# Upstream PHY Link Pilot Pattern for 802.3bn

Leo Montreuil, Broadcom

# Upstream PHY Link Pilot Pattern

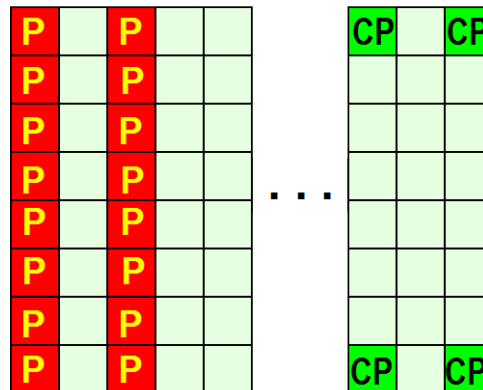
- Upstream PHY Link Channel is ranged and synchronized, no preamble required.
- Propose using following pilot pattern for PHY Link (section 102.3.2):

- Adopt and incorporate in the draft the Upstream PHY Link Pilot Pattern on slide 2 of montreuil\_3bn\_05a\_0514.pdf
- Moved:
- Seconded:
